Locations: 75 Neelin Drive, Carleton Place, ON - Carleton Place Arena

Reference: [100-2608] Carleton Place Arena - Building Automation System

This Addendum forms part of the contract documents and is to be read, interpreted, and coordinated with all other parts. The cost of all contained herein is to be included in the contract sum. The following revisions supersede the information contained in the original drawings and specifications issued for the above-named project to the extent referenced and shall become part thereof. Acknowledge receipt of this Addendum by inserting its number and date on the Tender Form. Failure to do so may subject the Bidder to disqualification.

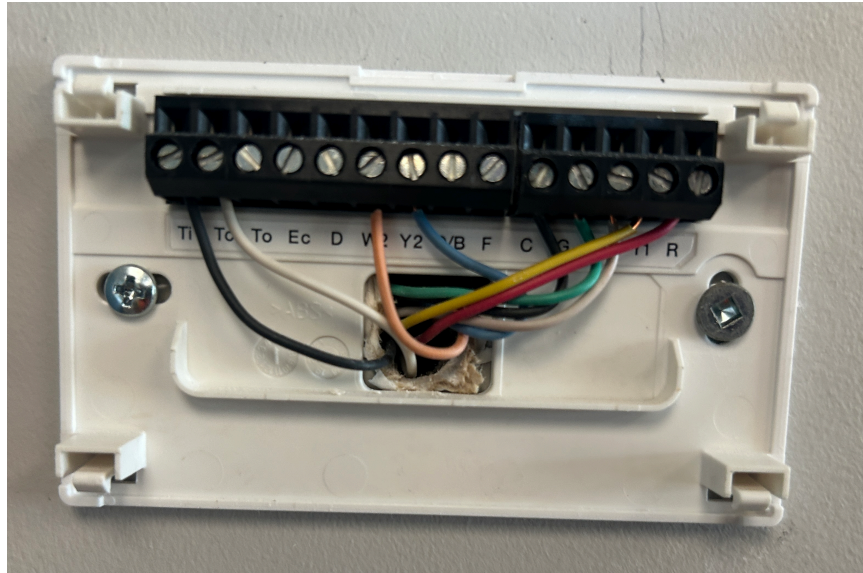
23. Existing RTU Controls (RTU-4, 5, 6) - Can you confirm whether the existing RTUs use:

- a. Proprietary thermostats (4-wire: R, i+, i-, C); or

- b. Conventional thermostats (R, G, Y1, Y2, W1, W2, O, C)?

Please refer to picture for typical wiring of all three rooftop units (RTU-4, RTU-5, RTU-6):
